UNITED STATES OF AMERICA  
NUCLEAR REGULATORY COMMISSION

## BEFORE THE ATOMIC SAFETY AND LICENSING BOARD

**OGLALA SIOUX TRIBE'S**  
**INITIAL POSITION STATEMENT**

## **OST Contention 2: Failure to Include Adequate Hydrogeological Information to Demonstrate Ability to Contain Fluid Migration**

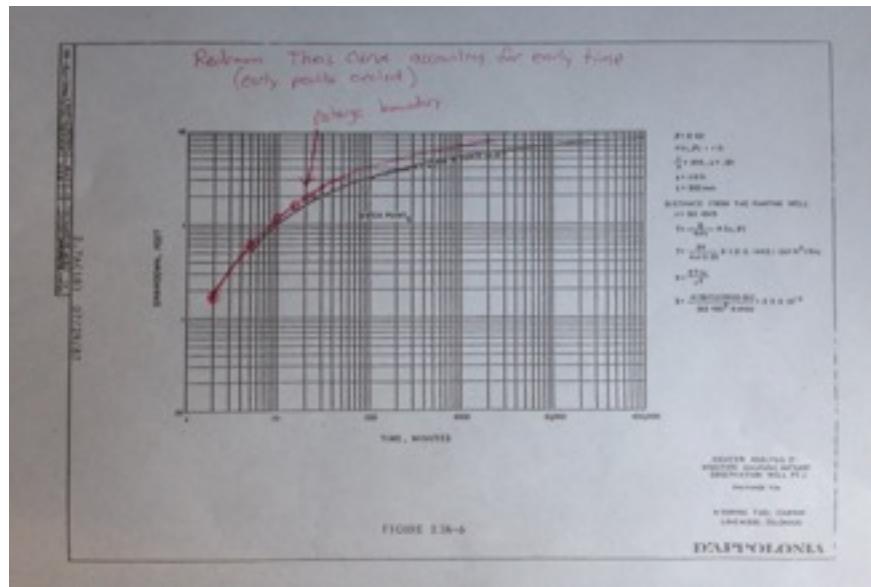
F. The single, solitary pumping test performed at the MEA was impacted by hydrogeologic influences off-site that were not part of the area to be evaluated. Because of the elongated nature of the MEA, the cone of depression's radius of influence for the solitary pumping test extended significantly off-site, well past the boundaries of the narrow portion of the property. The pumping test drew water from these off-site locations. This is significantly impactful as much of the analyses selectively addressed only late time data, which is more influenced by off-site factors.

**OST005 at 4: Dr. Kreamer re-drawn Figure 2.7A-6, with Theis type-curve matching early time in red. Early data points are circled – late time data below type curve indicates recharge.**

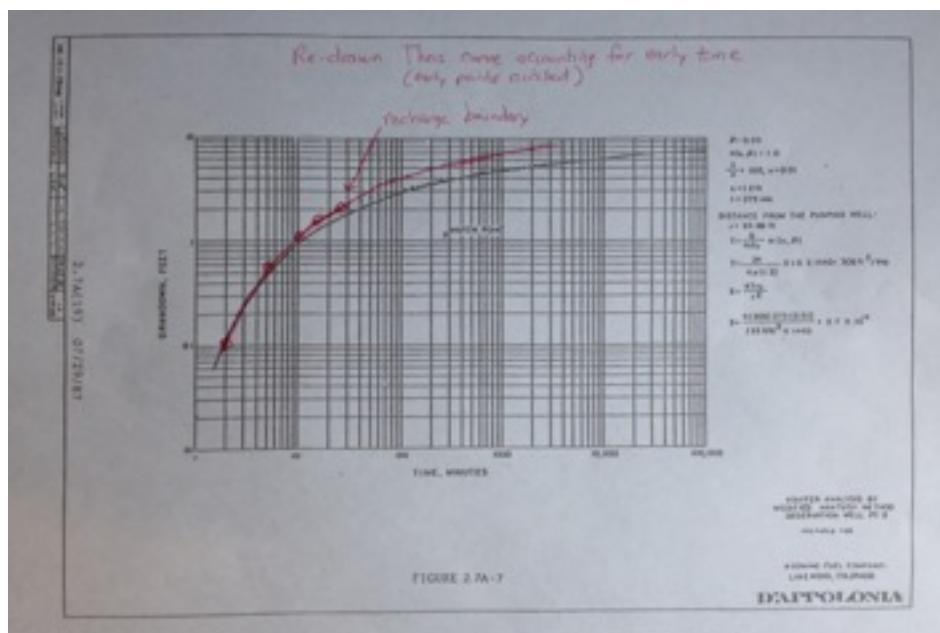
**Basis:** Previous hydrogeologic testing identified non-homogeneous anisotropic conditions in properties adjacent to the MEA. Ten aquifer tests were performed at the or around the Crow Butte Resources (CBR) site and five of those tests were invalidated by CBR because of possible vertical leakage (Tests 5 through 9 in 2004 and 2005). Information on those pumping tests was not provided. For CBR Aquifer Test One the CBR report explicitly states on page 2.7A (15) [OST006 at 16], "*Figures 2.7A-4 through 2.7A-7 give the apparent indication of leakage especially noticeable at late times.*" On page 2.7A (8) [OST006 at 9] in the CBR report the authors state that, "*Based on significant deviation of the pump test data from the Theis type curve in the original analysis the USNRC questioned the use of a non-leaky analysis method in the data.*" On page 2.7A (22) [OST006 at 23] they state, "*Examination of the drawdown/time curves plotted for observation well indicated that some leakage from confining bed occurred*

*during the pumping test.*" Additionally, Dr. David Kreamer in testimony regarding pumping test one showed departure from the classic Theis curve consistent with leakage (See Exhibits 1 and 2 below). [OST005 at 4] This same departure is evident in the MEA pumping test. [OST009 at 80-96]
